**RE: Development of Regional Impact (DRI #1058)
Northeast Atlanta Beltline**

From: Doug Young [DYoung@AtlantaGa.Gov]
Sent: Wednesday, May 31, 2006 3:06 PM
To: Haley Fleming
Cc: Steven R. Cover; Karen Huebner; Alice Wakefield; ebcoyle@midnspring.com
Subject: DRI #1058 - Northeast Atlanta Beltline - AUDC Comments and Information

From: Yost, Steve [mailto:Steve.Yost@dot.state.ga.us]
Sent: Wednesday, June 21, 2006 11:57 AM
To: rbechtel@grta.org
Subject: Northeast Atlanta Beltline DRI

RAIL TRANSIT RIGHT OF WAY ENVELOPE

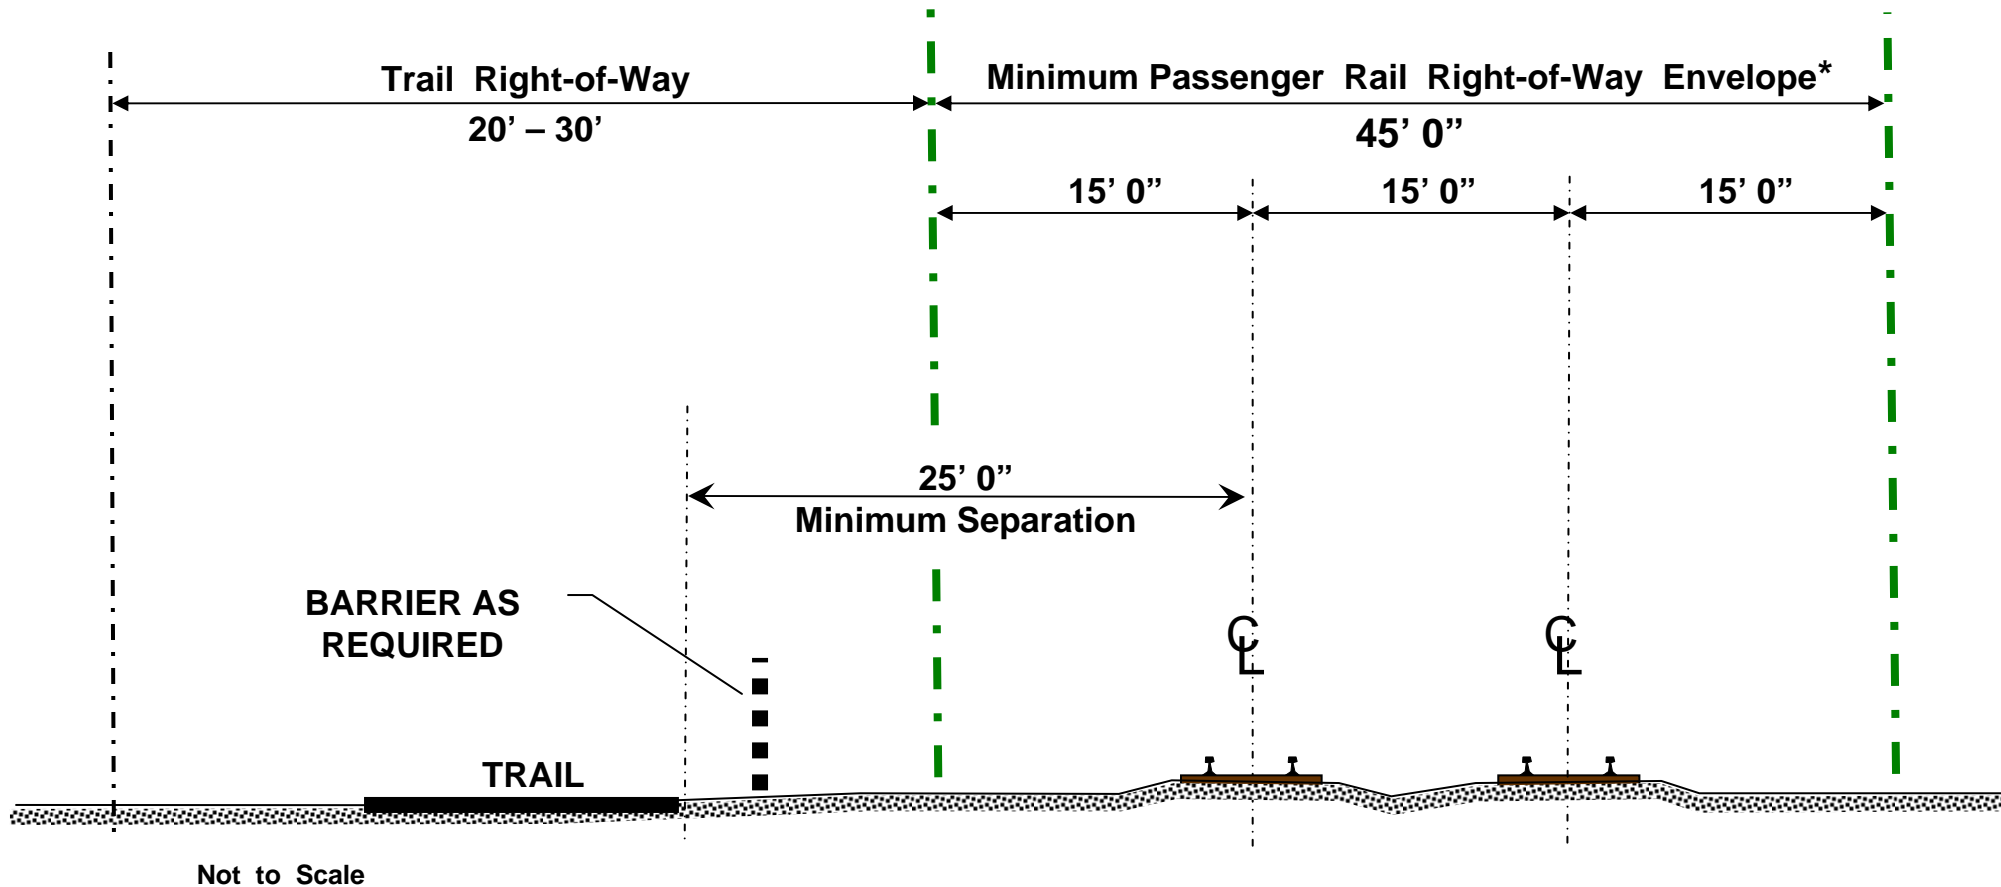
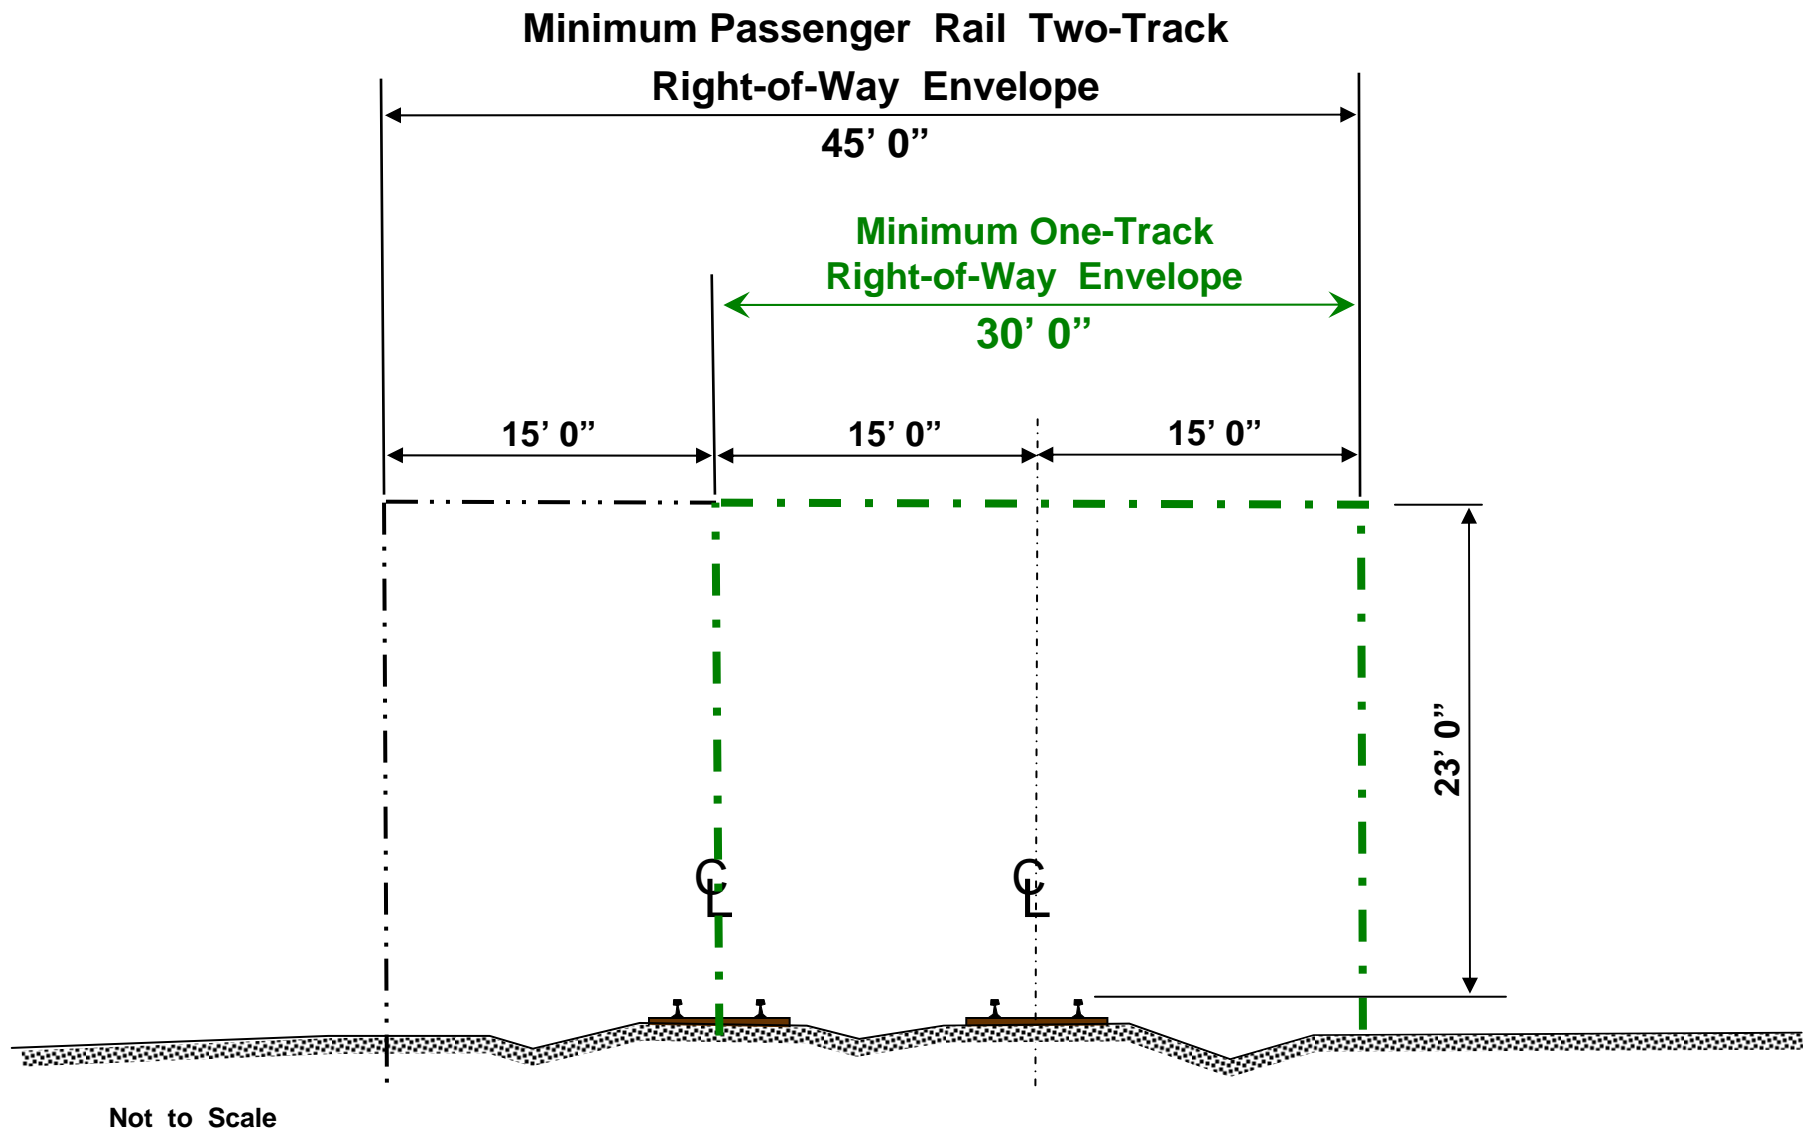
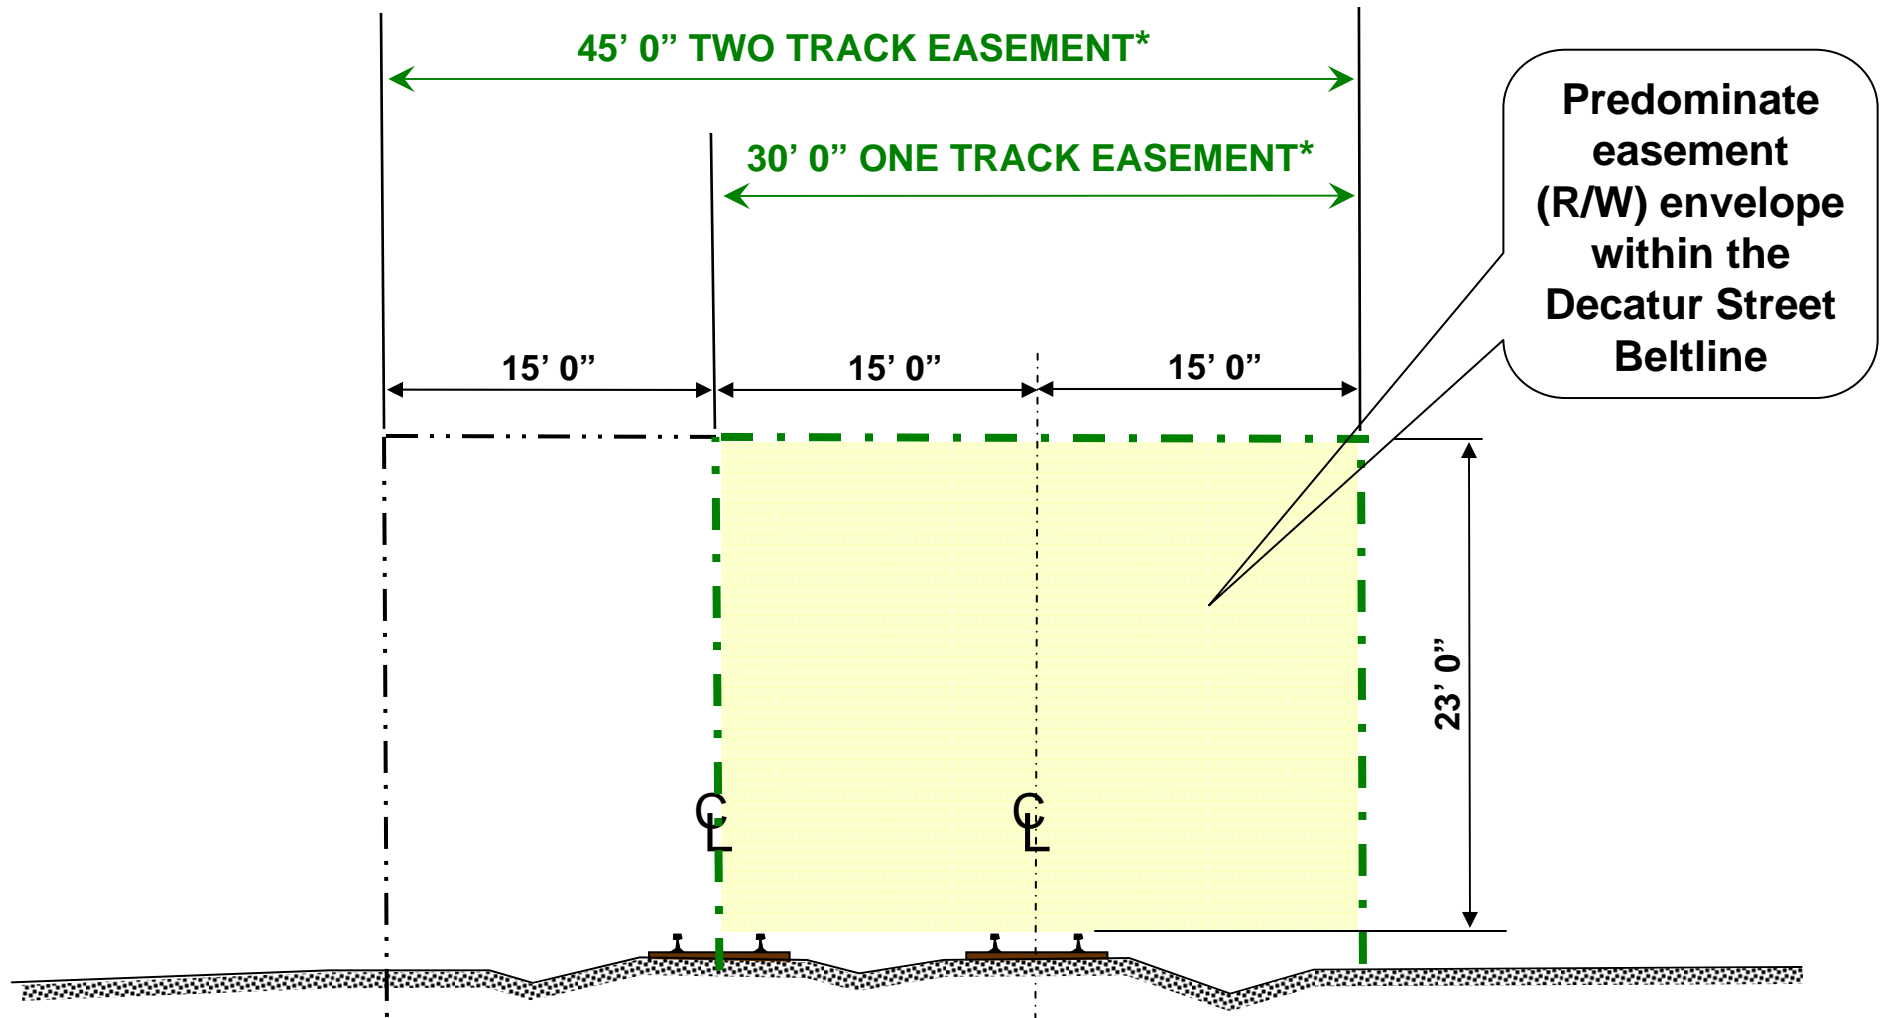
- The required width for the use of FRA-compliant service is forty-five feet (45', see Attachment). This could be accommodated based upon existing railroad right-of-way and structures in the corridor. It is recommended that the trail right-of-way width be a minimum of 20', the nearest edge of the trail be a minimum of 25' from the centerline of the railroad alignment, and the trail be physically separated (by a barrier) for safety.

In short, selecting a 30' easement along the Decatur Belt and not providing for a 45' easement that the Department recommends (as required width for the use of FRA-compliant service for double-tracked operations), places a key piece of the Department's commuter and passenger rail plans through the Northeast Atlanta Beltline area in serious jeopardy of ever becoming a reality.
